ADVISORY  
 BULLETIN

No. 2000-10  
(Mercury Jet Drives No. 2000-01)

## Oil Pump Coupler/Bearing – Sport Jet 175

175HP Sport Jets: 1997, 1998, 1999 Model year product

- a** - Oil Pump
- b** - Coupler/Bearing
- c** - Driven Gear
- d** - Oil Gear

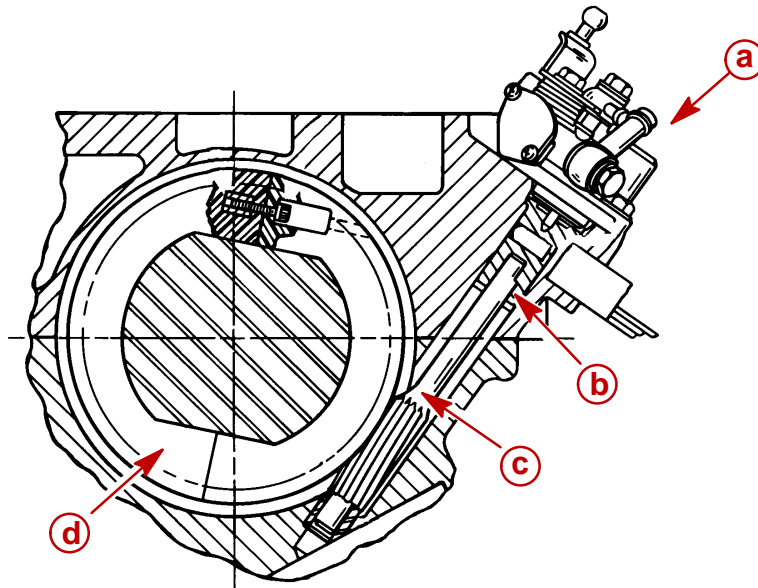
Mercury Marine will replace the coupler/bearing on affected Sport Jet 175 powerheads as listed above.

**a** - Identification Mark

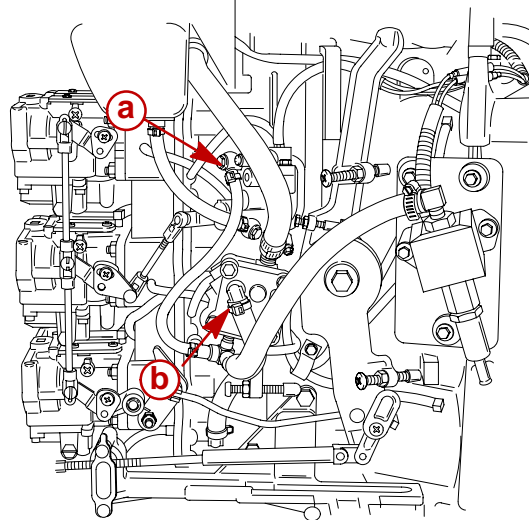
The new coupler/bearing can be identified by a “X” scribed on the end or a “-3” molded at the same location. See figure below for location of the identification mark.

Visually inspect the coupler/bearings in **your** parts inventory. If they do not have the identification (“X” or “-3”) marked on the end, return them with a warranty claim referencing the service bulletin (2000-10). **DO NOT USE THEM FOR REPAIRS. REMOVE THEM FROM YOUR INVENTORY AND USE ONLY THOSE COUPLER/BEARINGS SPECIFIED IN THIS BULLETIN.**
